# Evergreen Drive Questions and Responses

11/17 19 Appleton DPW

Figure 1 Proposed Typical Cross Section for Evergreen Dr

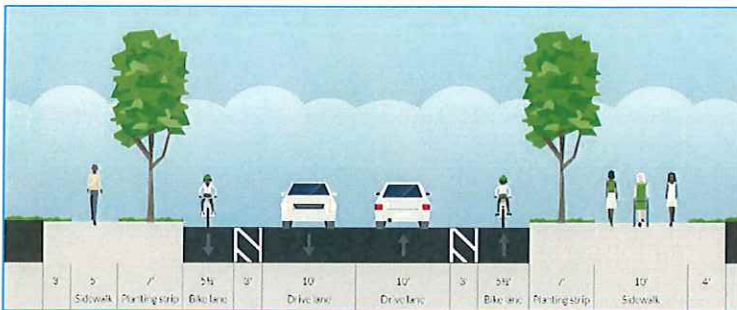
**How does the width of the proposed road compare to our older "standard" collector streets?** Until recently, when collector roadways like Evergreen Drive were urbanized in Appleton, they were built at a width of 37 feet, which is fairly standard from community to community. This design standard was intended to allow for safe passage of two-way traffic, while also allowing additional space for delivery vehicles, refuse trucks, etc. The proposed design for this section of Evergreen Drive would be built to a nearly identical width of 38 feet, but the space would be used much differently, and it would provide much safer and more comfortable bicycle and pedestrian accommodations.

**Would widening the roadway increase speeds?** While it is true that wider lanes tend to result in increased traffic speeds, the proposed design will actually *narrow* the marked automobile lanes from the existing 12 feet to the proposed 10 feet. This type of best practice has consistently been shown to reduce speeds and increase safety throughout the country.
